Project # 40441

Subject: **Proposed Modification of Vapor Mitigation / Extraction System for
Community Within the Corridor – East Block
2748 N 32nd Street, Milwaukee, WI 53208
BRRTS # 02-41-263675 FID 241025400**

Remedial Action Review Response

FIGURE 2

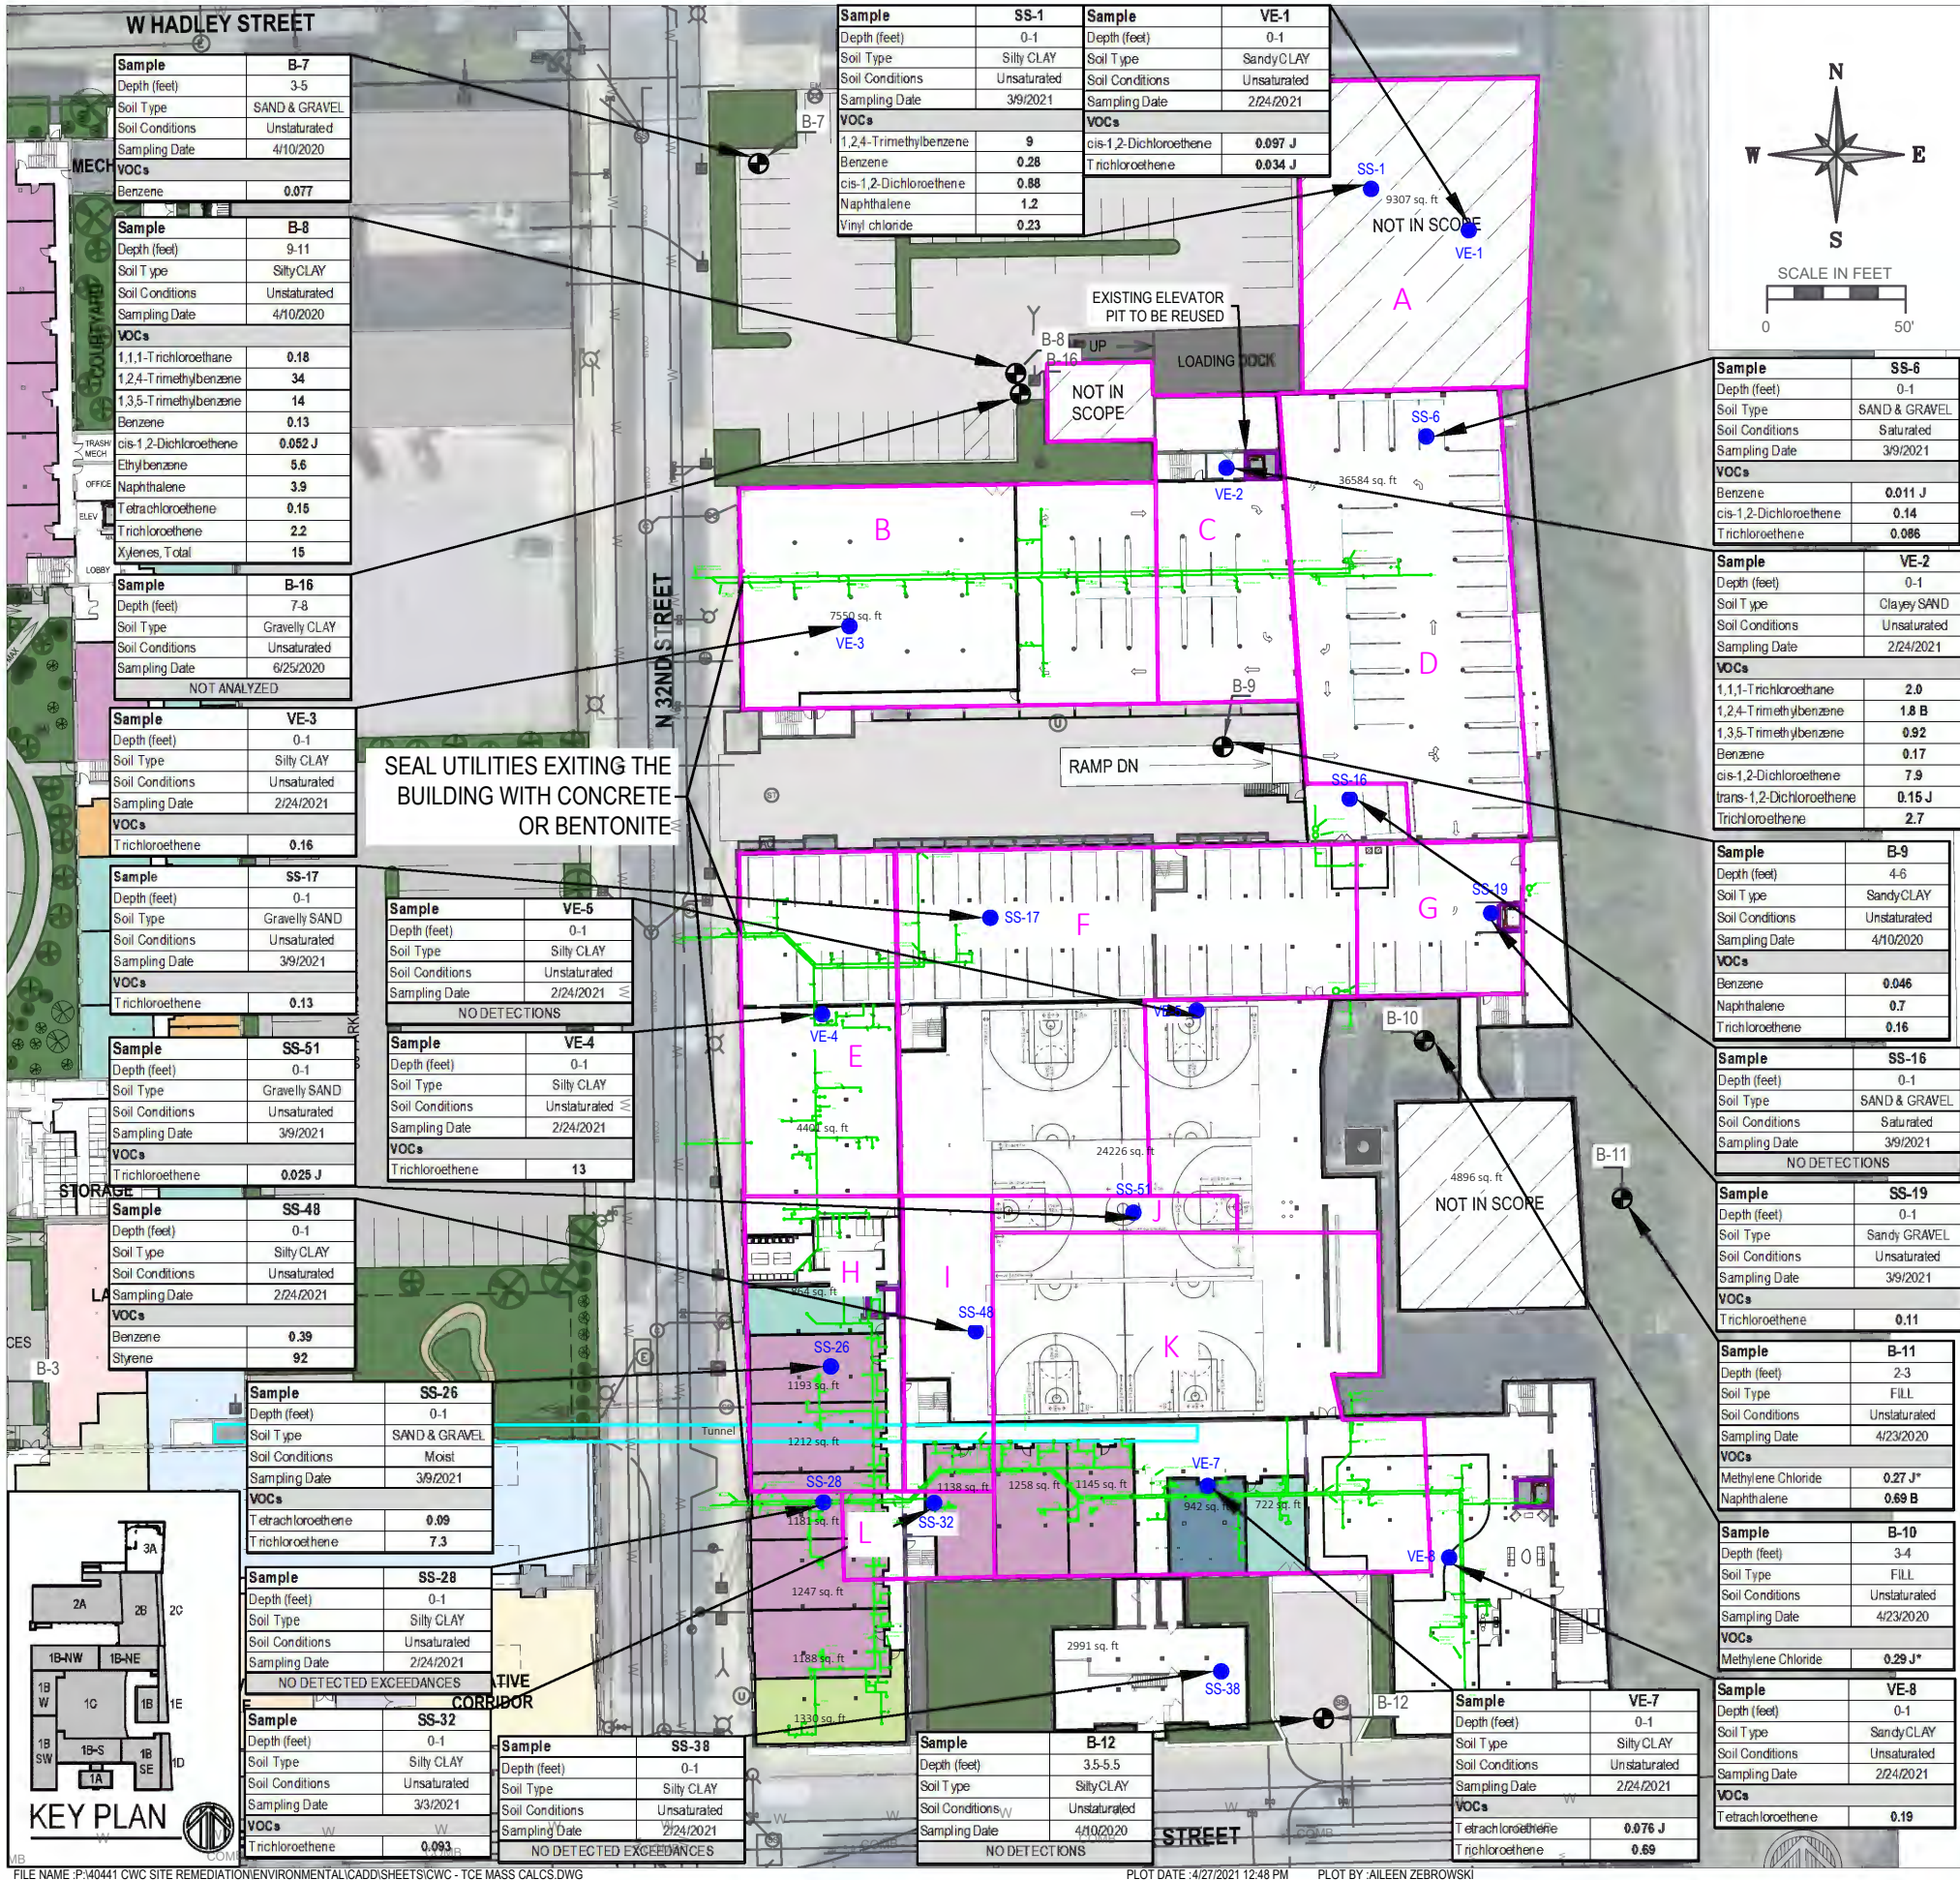
To accomplish sufficient TCE removal, KSingh is proposing that removal of concrete and excavation of the top 6 inches of underlying clay be performed in the area of the greatest TCE concentrations in soil as shown on Figure 3. Approximately 320 tons of soil are proposed to be removed as part of hotspot removal which will account for approximately 6.4 pounds of TCE. Another 2.4 pounds of TCE are estimated to be removed for trenching for the vapor extraction system and utilities which will bring the overall total to 8.8 pounds of TCE removed. The clay soils will be replaced by granular fill, covered with a 10-mil plastic vapor barrier, and the concrete will be restored. The granular fill will accentuate vapor recovery in the area of highest residual contamination and guarantee depressurization under the sub-slab of residential apartments.

1. The proposed system has been modified to maintain negative pressure under the entire building with the addition of several legs.
2. Hot spot removal to reduce the mass of TCE by 10% or more and to increase vapor recovery of the greatest concentration of TCE contamination has been proposed.

FIGURE 4

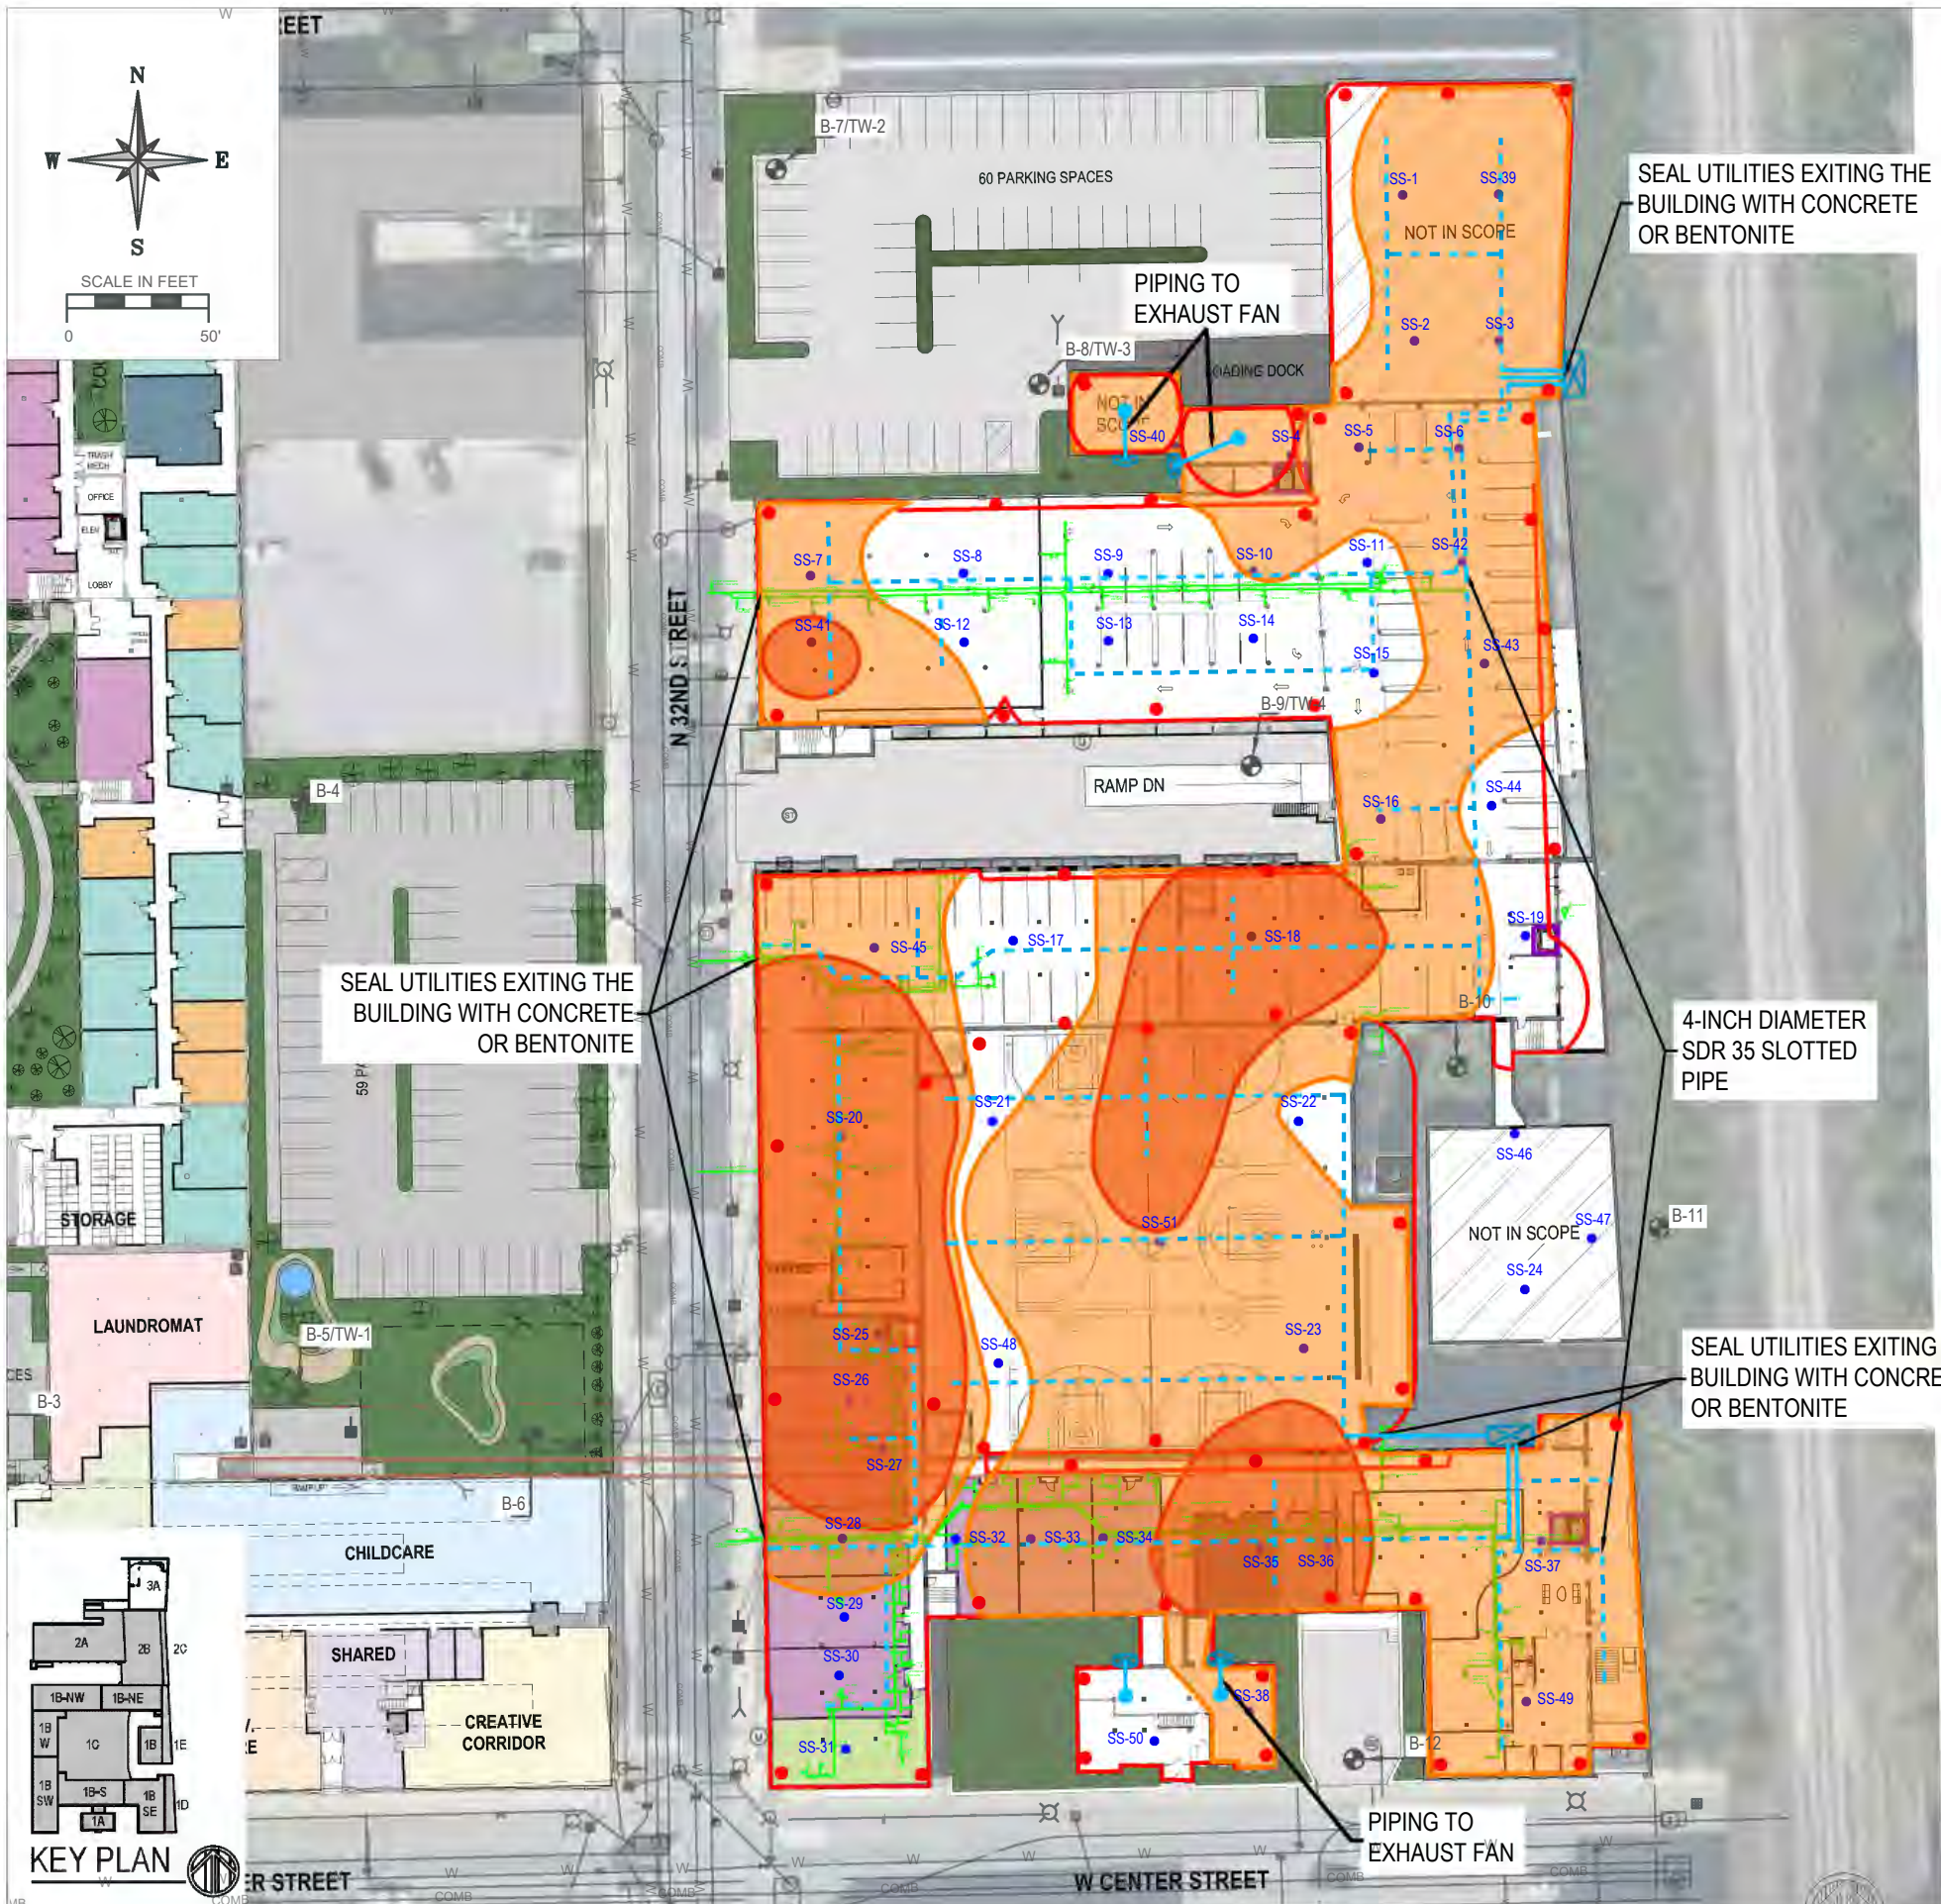
Fifty-five (55) sub-slab vacuum measurement points will be established by drilling holes in the slab. The locations of the vacuum measurement points are shown on Figure 4. The points will be sealed in between measurements. After collection of the first air sample, a survey will be made of cracks and joints in the area of the building where the pilot test is being conducted and smoke testing will be performed to identify leaks and short circuiting. Vacuum measurements will then be taken and recorded. The recorded measurements will be analyzed for areas of low and no vacuum and further investigation will be conducted in that area to identify causes of vacuum loss. The process will be repeated on the second and third days. The findings of the pilot test will be reported to the WDNR in a pilot test report along with recommendations for system modifications.
